**Case 22708 –
Substantive Site Plan
Approval**

1325 Lower Water Street,
Downtown Halifax

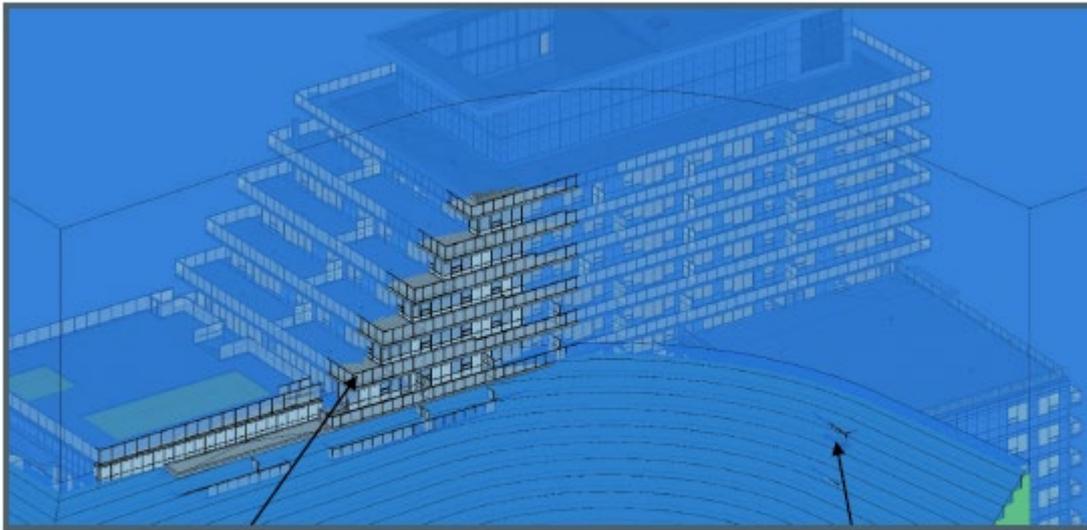
2.10i Ensure building height immediately adjacent to the 8 metre setback shall not be higher than 12.5 metres. Height may increase as distance from the boardwalk or the water's edge increases at a rate of approximately one metre of vertical height for every one metre of horizontal stepback from the boardwalk or water's edge.

Portions of the north-east building face on levels 12, 13, 14, 15 and 16 that are within 30 metres of OHWM and over the required 33.7 metres of building height limit require this variance.

Portion of the railing that is over the required 31.37 metres of building height and within 30 metres of OHWM setback requires this variance.

Variance Category 2 – Upper Storey Side Yard Stepback Variance

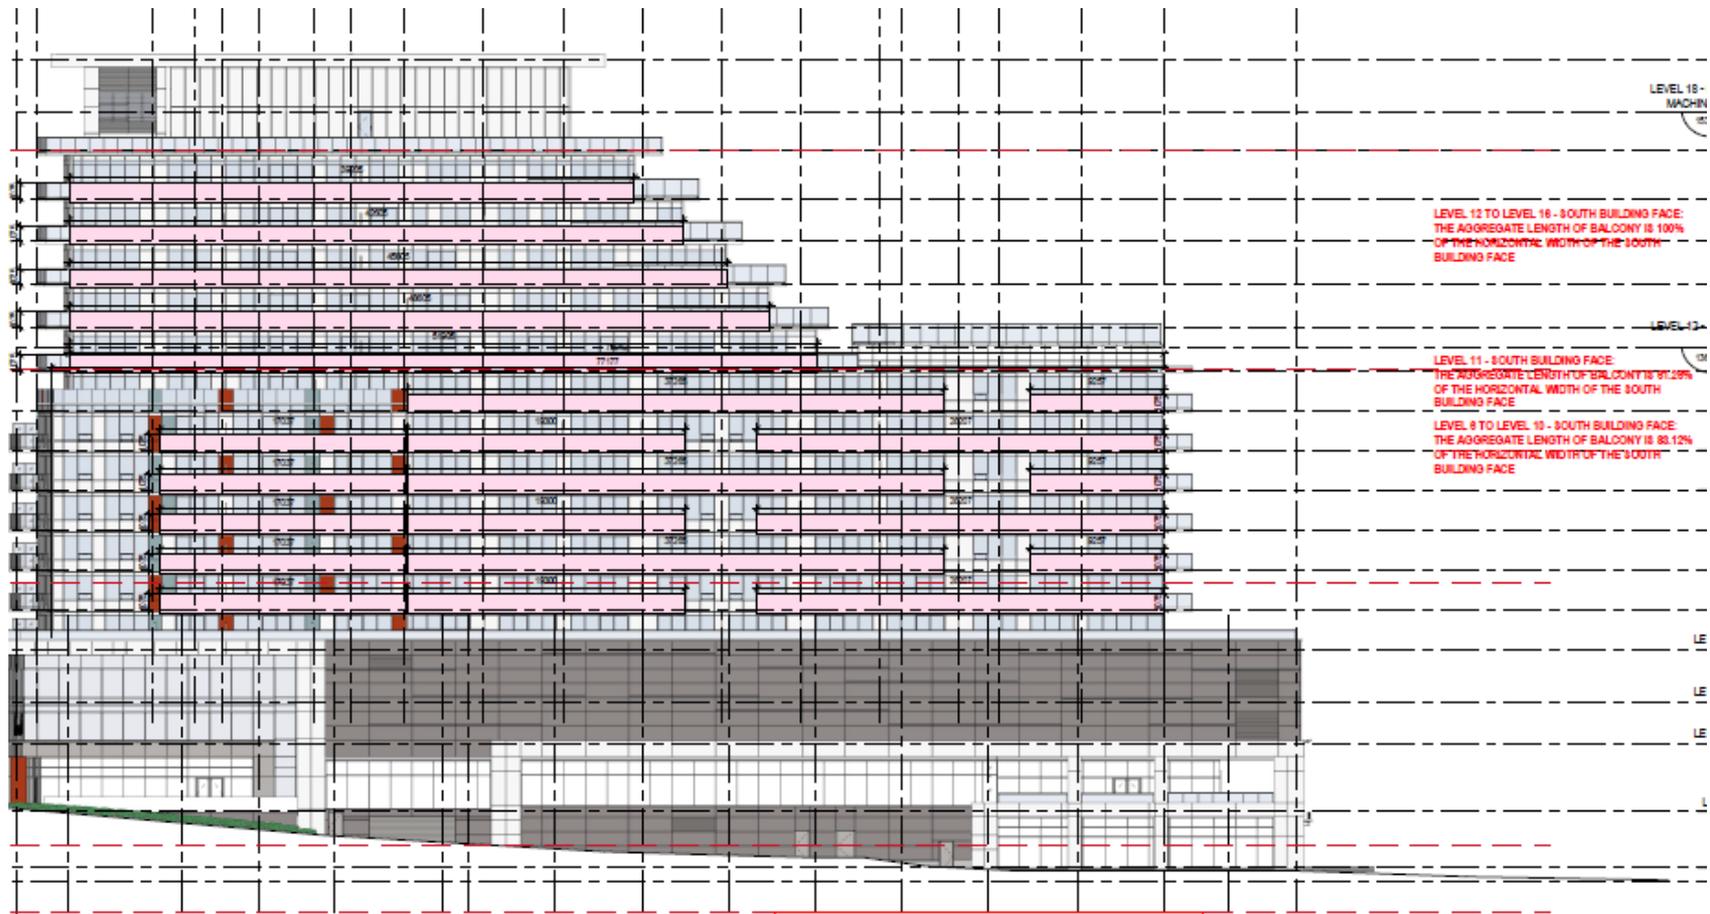
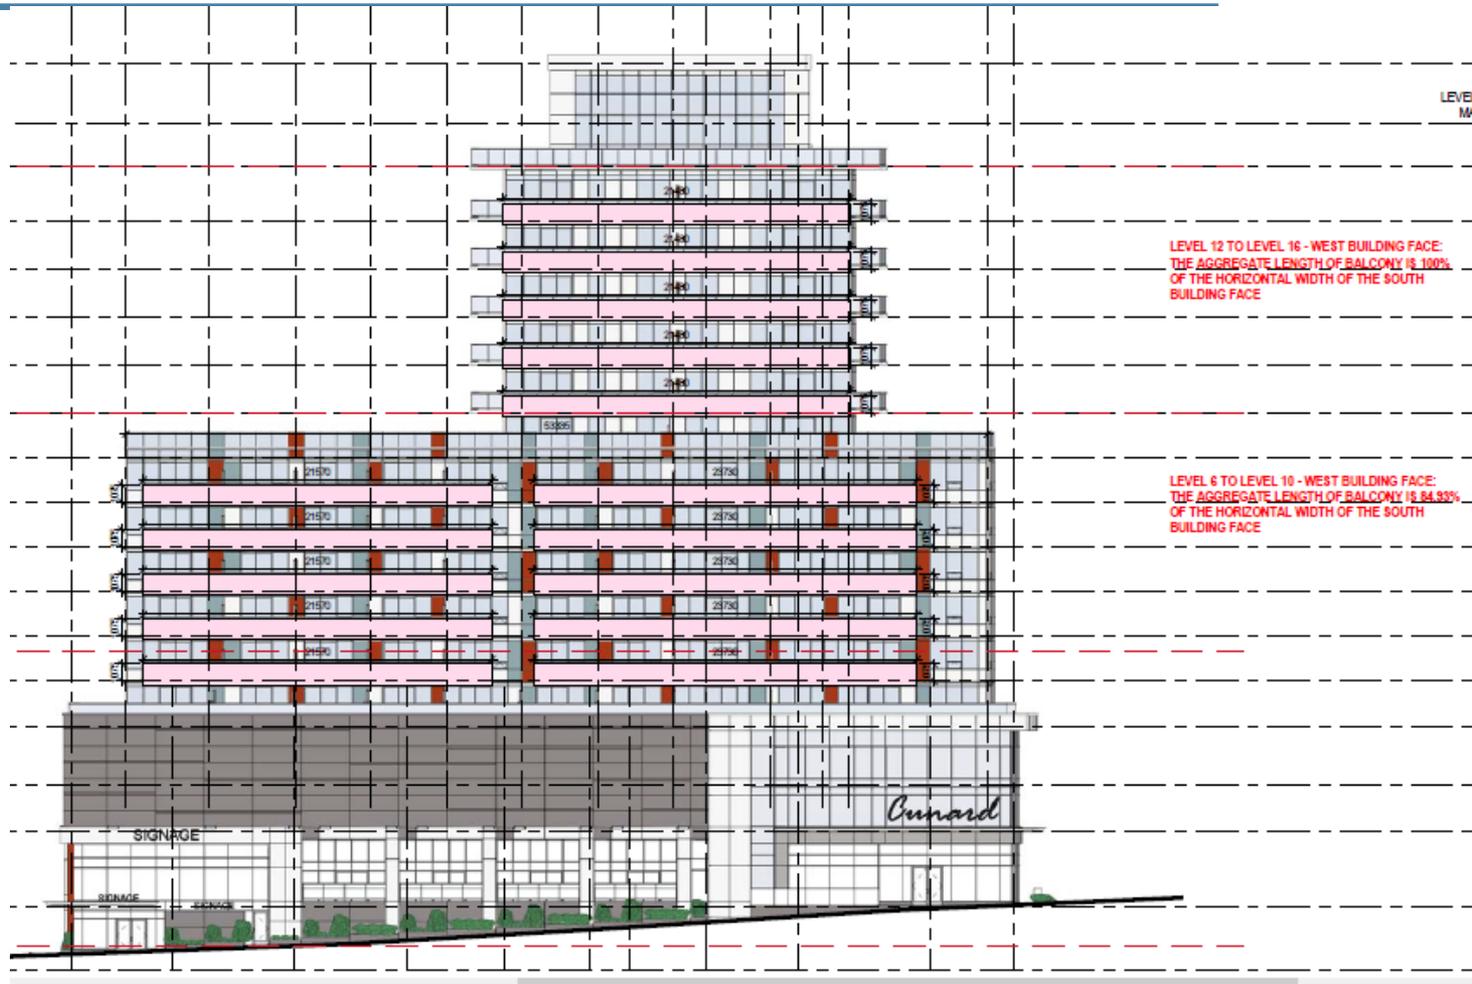
Section 10(13) (Variance #5) which allows balconies to be permitted encroachments into a setback or stepback provided that aggregate length of balconies does not exceed 50% of building face.

LEVEL 12 TO LEVEL 16 - SOUTH BUILDING FACE:
THE AGGREGATE LENGTH OF BALCONY IS 100%
OF THE HORIZONTAL WIDTH OF THE SOUTH
BUILDING FACE

LEVEL 11 - SOUTH BUILDING FACE:
THE AGGREGATE LENGTH OF BALCONY IS 91.25%
OF THE HORIZONTAL WIDTH OF THE SOUTH
BUILDING FACE

LEVEL 8 TO LEVEL 10 - SOUTH BUILDING FACE:
THE AGGREGATE LENGTH OF BALCONY IS 88.12%
OF THE HORIZONTAL WIDTH OF THE SOUTH
BUILDING FACE

LEVEL 6 TO LEVEL 16 - SOUTH BUILDING FACE TOTAL:
THE TOTAL AGGREGATE LENGTH OF BALCONIES IS 86.29%
OF THE HORIZONTAL WIDTH OF THE SOUTH
BUILDING FACE TOTAL

Variance Category 2 – Upper Storey Side Yard Stepback Variance

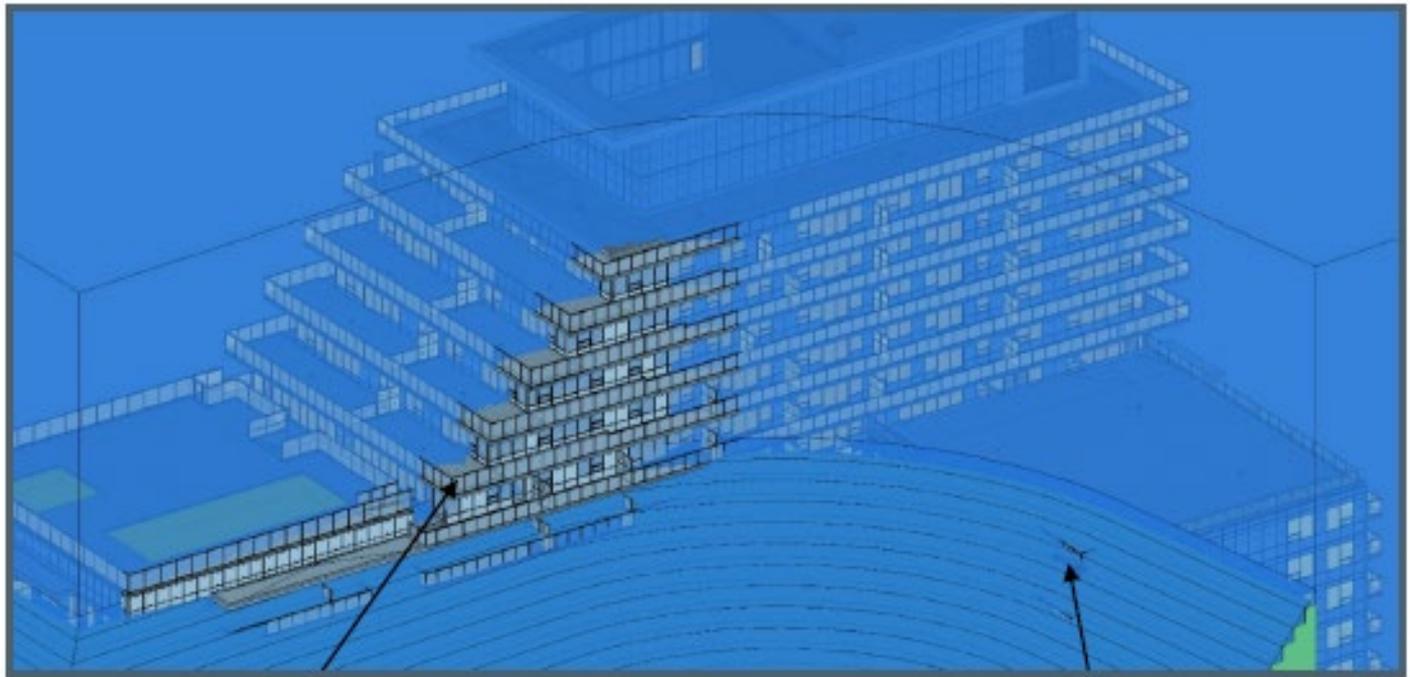
Section 10(13) (Variance #5) which allows balconies to be permitted encroachments into a setback or stepback provided that aggregate length of balconies does not exceed 50% of building face.

Staff recommends refusal based on the following:

- 3.6.6a – the requested variance is inconsistent with the Design Manual and it does not meet either of the criteria below
- 3.6.6b – where the height of the building is substantially lower than the maximum permitted building height and the setback reduction is proportional to that lower height; or
- 3.6.6c- a reduction in setback results in the concealment of an existing blank wall with a new, well designed structure.

Variance Category 5 – Tower Width and Separation

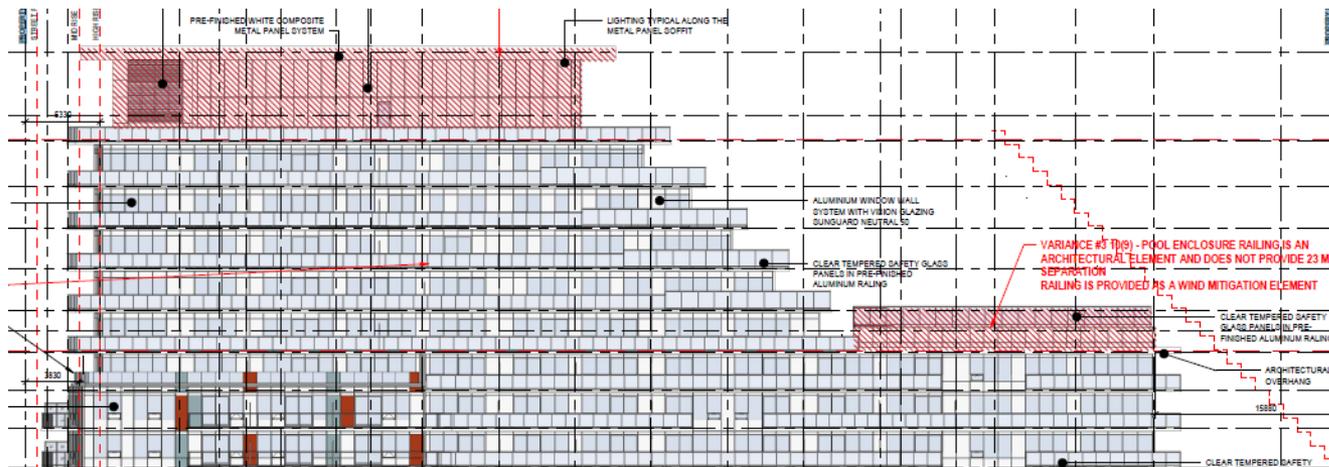
Section 10(9) of the LUB (Variance #3) requires that any portion of a high-rise building above a height of 33.5 m shall be separated from another non residential portion of the building by a minimum of 23 m.

○ **Staff recommends refusal based on the following:**

- 3.6.7a – the requested variance is inconsistent with the Design Manual; and it does not meet the following
- 3.6.7b – the modification results in a clear public benefit such as the remediation of an existing blank building wall;

Variance Category 2 – Upper Storey Side Yard Stepback Variance

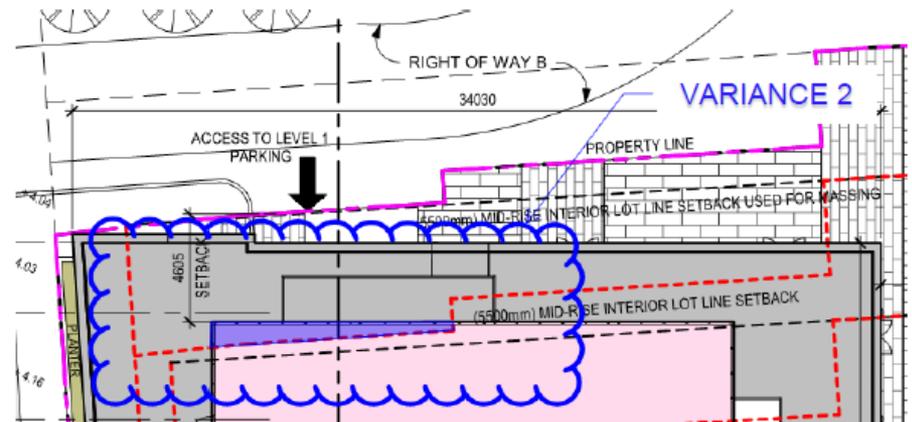
Section 10(4) of the LUB (Variance #2) requires that any portion of a mid-rise building above a height of 18.5 m shall be setback 5.5 m from interior lot lines.

Required Setback – 5.5 metres
Provided Setback – 5.5 metres [4.6 metres only at the N-W corner]

○ **Staff recommends approval based on the following:**

- 3.6.6a – the requested variance is consistent with the Design Manual
- 3.6.6b – where the height of the building is substantially lower than the maximum permitted building height and the setback reduction is proportional to that lower height

Variance Category 3 – Maximum Height

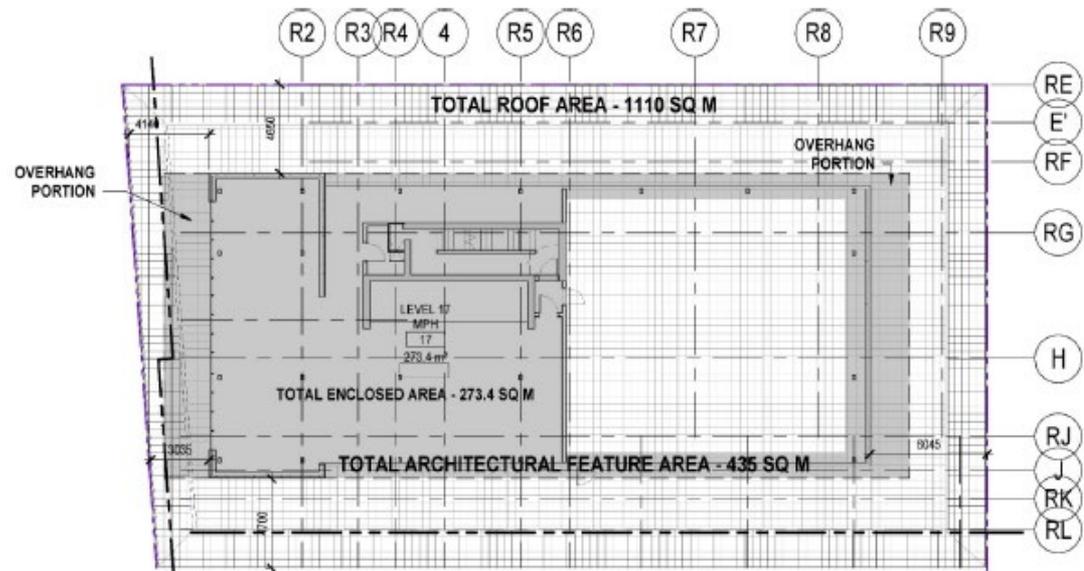
Section 8(8) of the LUB (Variance #1) requires that a mechanical penthouse shall not occupy more than 30% of the roof area.

- Staff recommends approval based on the following:

- 3.6.8a – the requested variance is consistent with the Design Manual
- 3.6.8b – the mechanical penthouse and railings do not constitute an increase in gross floor area
